Our Ref: 22331

28 July 2023

**RE:     CANCER CARE MANNING-GREAT LAKES  
          88 – 90 CORNWALL STREET, TAREE  
          RESPONSE TO COUNCIL'S REQUEST FOR FURTHER INFORMATION (RFI) - PARKING**

FIGURE 5.2 DESIGN ENVELOPE AROUND PARKED VEHICLE TO BE KEPT CLEAR OF COLUMNS, WALLS AND OBSTRUCTIONS

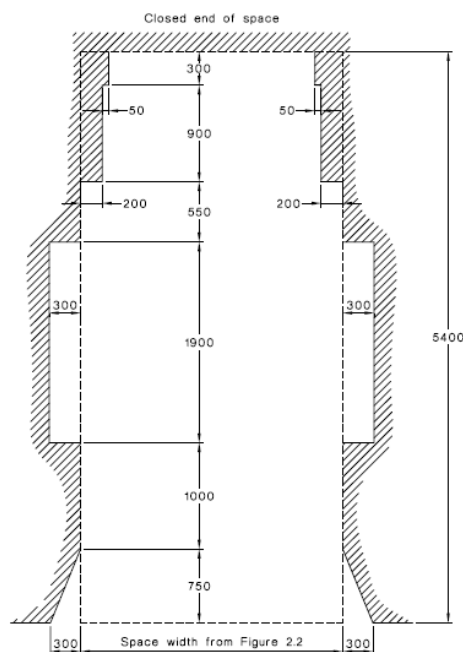
Car parking spaces allocated to the employees are to be designed in accordance with the Australian Standard AS2890.1:2004 User Class 1A, and car parking spaces allocated to the patients are to be designed in accordance with Australian Standard AS2890.1:2004 User Class 3, or designed as accessible space in accordance with AS2890.6. User Class 1A spaces are a minimum of 2.4m wide, 5.4m long with a 5.8m aisle width. User Class 3 spaces are a minimum of 2.6m wide, 5.4m long with a 5.8m aisle width. Accessible spaces are a minimum of 2.4m wide, 5.4m long with an adjacent shared space of the same dimensions. A 300mm clearance is to be provided on either side of a car parking envelope as per Figure 5.2 of AS2890.1:2004.

6 car spaces are designed in accordance with User Class 1A for staff parking. 2 car spaces are designed in accordance with User Class 3 for patient parking. 2 spaces at the front car park are designed as accessible spaces in accordance with AS2890.6 for patient parking. An ambulance bay & pick-up/drop-off bay, which allows for a temporary stop only, is located in front of the accessible parking spaces.

The proposed car park layout is compliance.
